Hearings on an Intensification Planning Instrument, as a proposed plan change to the Upper Hutt City District Plan under the Resource Management Act 1991, Schedule 1 Subpart 6.

JOINT STATEMENT OF URBAN DESIGN EXPERTS (JWS 1)

11 July 2023

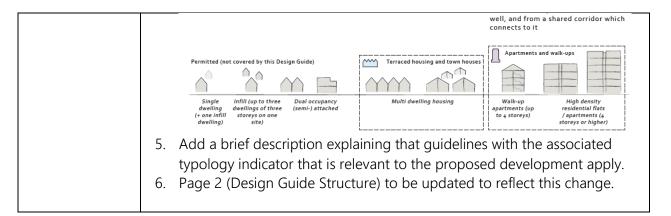
5. Refer to Section 9.3(e) of Mr Rae's statement, which states: "The details included in the high density explanation in red at the bottom of page 3 of the Design Guide are not consistent with the provisions of the IPI as they include permitted up to 24.5m height (standard is 20m see Section 42a version) and for more than four units, where it should be four or more"	6. Refer to Section 5.1 (9.3(e)) of Mr Coolen's evidence (Appendix C to right of reply) which responds: "The reference to permitted height in the high density residential zone has been revised to 20m to align with the Plan provisions"
AGREED POSITION	 Recommendation: Remove typology descriptions and photos from section 4 – this is because the guidelines are generally not specific to building typologies. Recommendation: Remove any references to mixed use from the guide The guidance should focus on the differences between dwellings that are at ground level such as a town house which includes ground and upper levels, versus dwellings that are above ground such as apartments. The icons should then advise which guidelines are relevant to the dwelling typology proposed Recommendation: Replace current typologies cross section with the below, which removes references to zones and height standards:
